VERMONT YANKEE NUCLEAR POWER CORPORATION

Subject: Vermont Yankee Proposed Change No. 133 - Spent Fuel Pool Expansion

Vermont Yankee Response to NRC Staff Technical Issues Identified in the January 21, 1988 Status Report

FIGURE 1
POOL TEMPERATURE

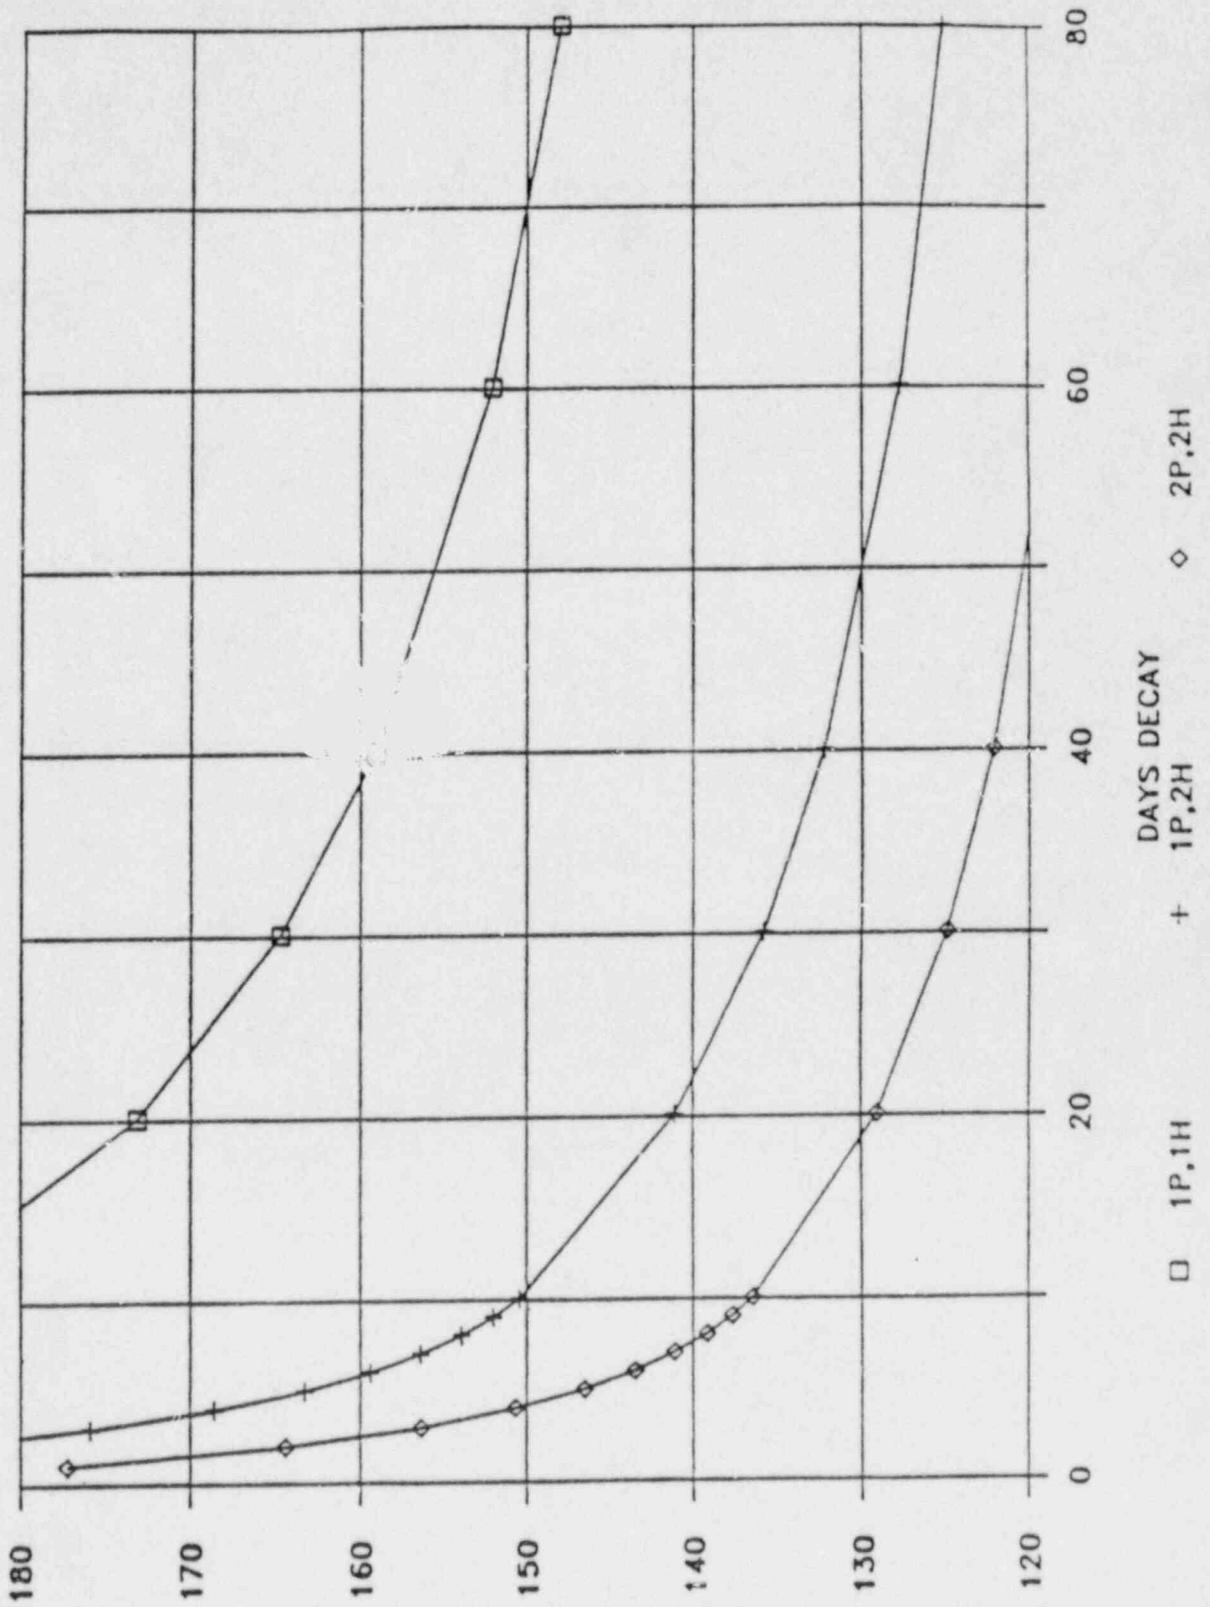
- 1A. 1971 ANS DRAFT STANDARD USED
- 1B. 9.1 MBTU/HR USED AS HEAT LOAD
- 1C. FSAR LISTS 2.23 MBTU/HR
- 1D. SINGLE FAILURE

running pump to each heat exchanger. Figure No. 1 summarizes the Vermont Yankee pool temperature capability for all combinations of existing SFPCS equipment. As can be seen from the one pump and two heat exchanger curve (middle curve), the pool temperature can be held to less than 150°F after 11 days of fuel decay. This figure is based on SRP heat load analysis methods that yield results comparable to heat loads calculated by NRC staff and attached to the "NRC Staff Response To NECNP's First Set Of Interrogatories And Document Request To The NRC Staff", dated August 5, 1987. Figure No. 2 makes a comparison of NRC staff and Vermont Yankee calculated heat loads at several days of decay. The heat loads at these points compare very well with each other, so it can be concluded that Vermont Yankee calculated heat loads are not in disagreement with the NRC calculated heat loads.
